Agenda item: AH 04 + AH 08
Source: Nokia
Title: CR 25.212-033rev1: Physical channel mapping and UE capabilities
Document for: Decision

CHANGE REQUEST

25.212 CR 033rev1 Current Version: **3.1.0**

Subject: **Physical channel mapping and insertion of DTX bits**

Figure 2: Transport channel multiplexing structure for downlink

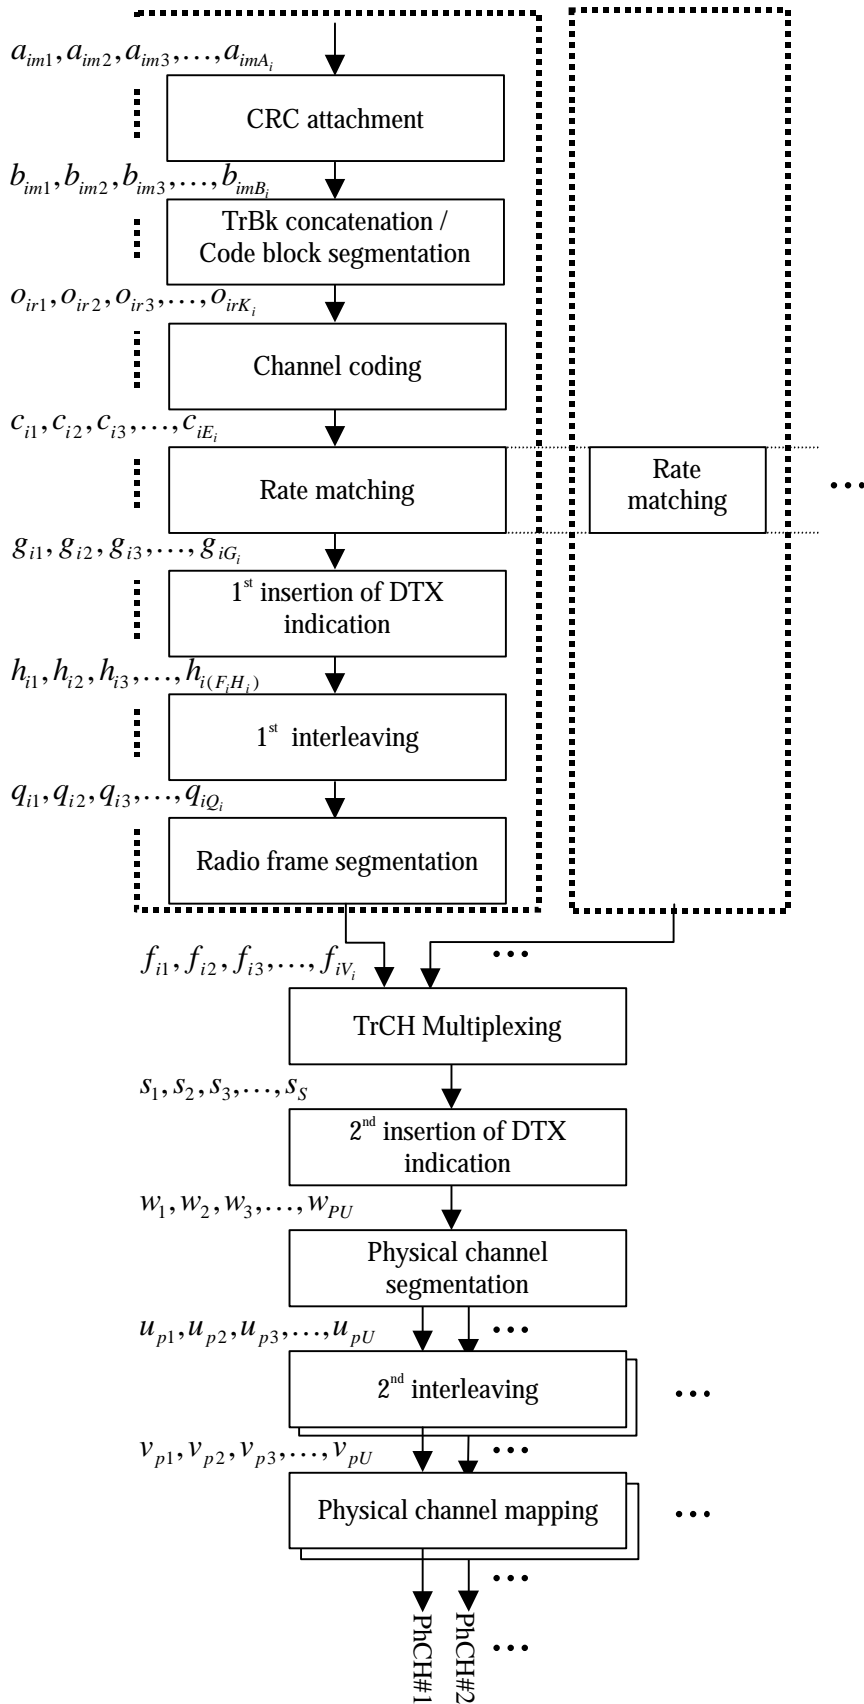
The benefit of b) is also that every time SF/2 method is used with TGL=7 with single frame method, it is only physical channel mapping section, that needs to be reconfigured. With the present method, all 4 blocks has to be reconfigured in that case: 2nd insertion, physical channel segmentation, 2nd interleaving, physical channel mapping.

The attached CR proposes to add 0.5 slot of DTX in physical channel mapping always with SF/2 method. Thus it is added for all TGL lengths, not only for TGL=7, to simplify the definition.

At the moment the number of CCTrCH bits is increased by 0.5 slot number of bits when going to SF/2, since 0.5 slot of DTX is inserted in 2nd insertion of DTX . In this CR the corresponding sections: 4.2.7.1.2, 4.2.9.2 and 4.2.12 are changed so that the number of CCTrCH bits remains the same in SF/2 method with TGL=7 per single frame as in normal mode, since here it is defined that the 0.5 slot of DTX is created in physical channel mapping section.
